FAG Service Info

Stabiliser strut 818 0429 10

Extra adapter washer

Models: Twingo II (CN 0...)

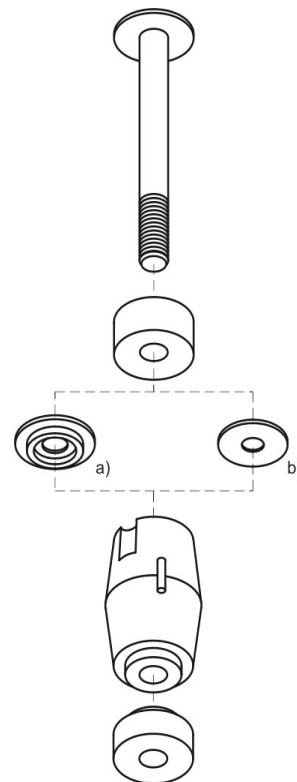
In contrast to the OE delivery scope, Schaeffler Automotive Aftermarket now supplies the stabiliser strut 818 0429 10 with an extra blue adapter washer.

The transverse link in the Renault Twingo II may be equipped with a borehole diameter of 16mm or 18mm for the stabiliser strut depending on the construction year. The extra blue adapter washer allows the stabiliser strut 818 0429 10 to be used for both transverse link models.

- Measure the boreholes for the stabiliser strut on the mounted transverse link
- Only use the white washer (b) for a diameter of 16mm
- Only use the blue washer (a) for a diameter of 18mm
